Economic Commission for Europe**Inland Transport Committee****World Forum for Harmonization of Vehicle Regulations****Working Party on General Safety Provisions****131st session**

Geneva, 13–17 April 2026

Awareness of the Proximity of Vulnerable Road Users:**UN Regulation No. 46 (Devices for Indirect Vision)****Proposal for the 08 Series of Amendments to Regulation
No. 46 (Devices for Indirect Vision)****Submitted by the expert from Germany on behalf of the Task Force on
UN Regulation No. 46***

Figure 1a

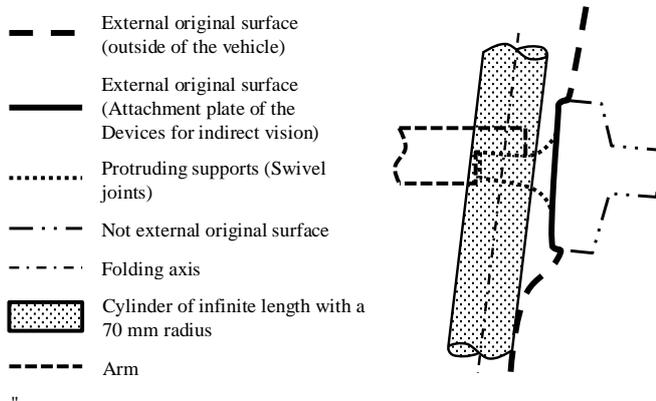
Figure 1a in Paragraph 2.7., amend to read:

"2.7. "External original surface" means the outside of the vehicle including the bonnet, the lid of the luggage compartment, the doors, the wings (fender), the roof, the lighting and light-signalling devices, the visible strengthening components, the support plate of devices for indirect vision and additional external original design surfaces defined by the manufacturer excluding protruding supports for devices of indirect vision.

Figure 1c

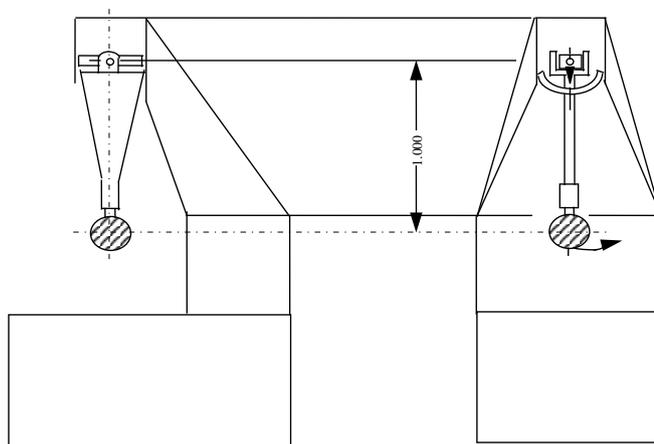
"6.3.2.1.1. The test rig consists of a pendulum capable of swinging about two horizontal axes at right angles to each other, one of which is perpendicular to the plane containing the "release" trajectory of the pendulum.

The end of the pendulum comprises a hammer formed by a rigid sphere with a diameter of 165 ± 1 mm, and at least on the impact side a 5 ± 1 mm thick rubber covering of Shore A hardness 50.

The end of the hammer may be formed by any other rigid shape having at least on the impact side a spherical shape and a 5 ± 1 mm thick rubber covering of Shore A hardness 50, if the equivalence of this shape is demonstrated through a mathematical model, to the satisfaction of the Type Approval Authority.

Figure 1c ~~shows an example below gives the dimensions (in mm) of the a test rig and the special design specifications:~~

Figure 7
Class IV fields of vision

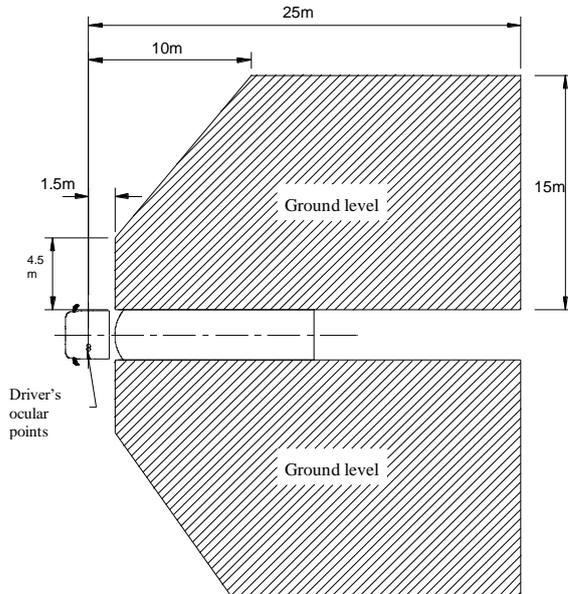
Figure 7 in Paragraph 15.2.4.4.2., amend to read:

The field of vision shall be such that the driver can see at least a 15 m wide, flat, horizontal portion of the road, which is bounded by a plane parallel to the median longitudinal vertical plane of the vehicle and passing through the outermost point of the vehicle on the passenger's side and which extends from at least 10 m to 25 m behind the driver's ocular points.

In addition, the road shall be visible to the driver over a width of 4.5 m, which is bounded by a plane parallel to the median longitudinal vertical plane and passing through the outermost point of the vehicle starting from a point 1.5 m behind the vertical plane passing through the driver's ocular points (see Figure 7).

Example 1

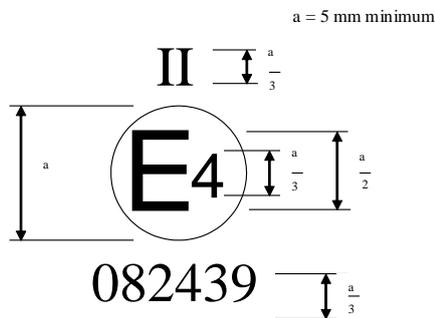
The above approval mark affixed to a device for indirect vision indicates that the device is a main rear-view device, of Class II, which has been approved in the Netherlands (E 4) pursuant to Regulation No. 46 and under approval number 072439 **082439**. The first two digits of the approval number indicate that Regulation No. 46 already included the 07 08 series of amendments when the approval was granted.
